Access Compliance Report

Public Rights-of-Way

(Pedestrian Signals)

Intersection ID: N/A	Main Street:	Cross Street: N/A	Location: N/A
ADA ID: 42B306934391	Signal Type: One Push Button-APS	Overall Compliance: No	Severity Score: BTN 1: N/A BTN 2: N/A No BTN: N/A
Codes/Mitigation Info/Possible Solution		Field Measurements/Component Compliance

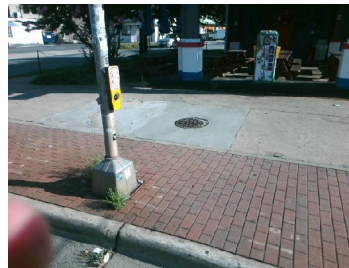
Surveyor Notes: TEXT HT 3/8

PROW/ADA: R410.6, R406.2, R209.1, MUTCD 4e.10

Possible Solutions: Remove & Replace
Replace APS Button With New APS Button.
